Product Change Notification / LIAL-18EJTL948

CCB 5082 Initial Notice: Qualification of ATP7 as an additional assembly site for selected MIC28514, MIC28515, MIC28516, and MIC28517 device families available in 32L VQFN (6x6x0.9mm) package.

CCB 5082
Pre and Post Change Summary
PCN #: LIAL-18EJTL948

Lead Frame Comparison

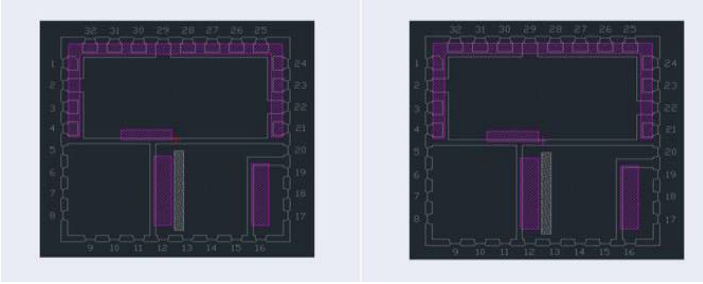
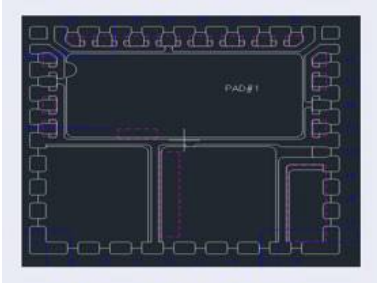
(ASE)		(ASE)		Philippines (P3/P4), INC. (ATP7)
Wire Material	CuPdAu		CuPdAu		CuPdAu
Die Attach Material 1	CDF625P8C8		CDF625P8C8		DAF CDF215
Die Attach Material 2 and 3	84-1LMISR4		84-1LMISR4		DAF CDF215
Molding Compound Material	EME-G631 H	EME-G700L A	EME-G631H	EME-G700L A	G631BQ Type F
Lead-Frame Material	C194		C194		C19400 FH
	See pre and post change attachment for lead frame comparison

Pre Change	Post Change
